Amendments to the Drawings:

Title: RECHARGEABLE BATTERY WITH A CONNECTING POLE

Appl. No.: 10/755,717

Annotated Sheet

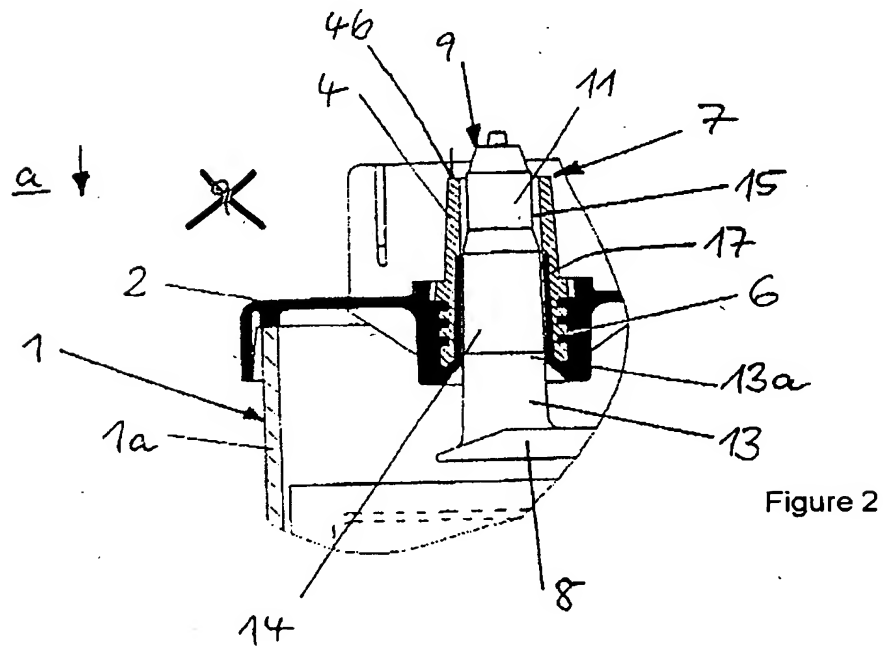
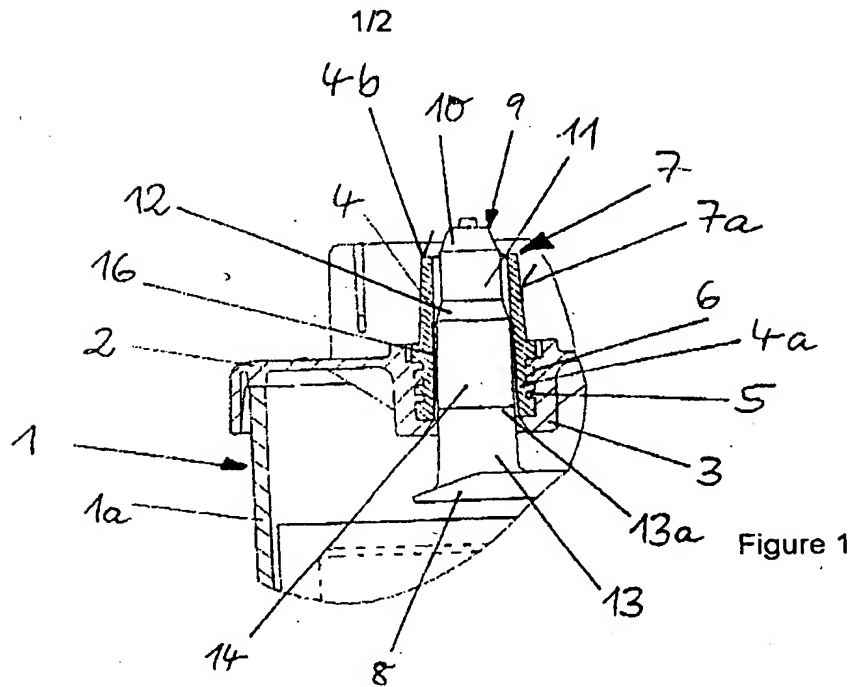
The specific change which has been made to Figure 2 is the removal of the reference numeral 9 not having a lead line, as shown in the attached annotated drawing sheet.

The drawings are objected to because Figure 2 contains two reference character 9. One reference character 9 has no lead indicating the part of the drawing it represents.

The Applicant has submitted a replacement drawing sheet amending Figure 2 to remove the reference numeral 9 not having a lead line. The Applicant respectfully requests that the objection to the drawings be withdrawn.
